Eardisland Parish Council wishes to object to the amended plans and documents submitted for P152779/F, Land adjoining Orchard Farm, Eardisland – Proposed construction of 5 no dwellings with garages. Formation of new access and private drive and close existing. Demolition of outbuilding, steel framed barn, wind tunnel and greenhouse.

Picture 6 clearly shows a car coming from the village on the wrong side of the road to avoid standing water on the road. Picture 7 shows standing water coming from the current Orchard Farm entrance leading to flooding across the road in rainfall

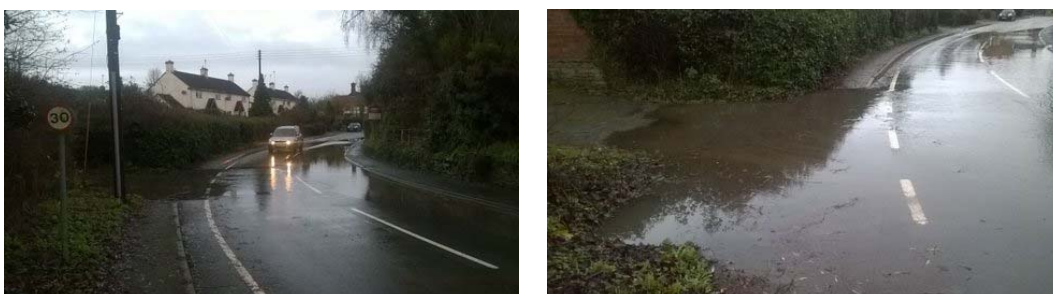
11. It is noted that the Highway Safety Assessment report is based on a site visit in fine and dry conditions. The photo at 1.4 contrasts greatly with the situation after rainfall as below
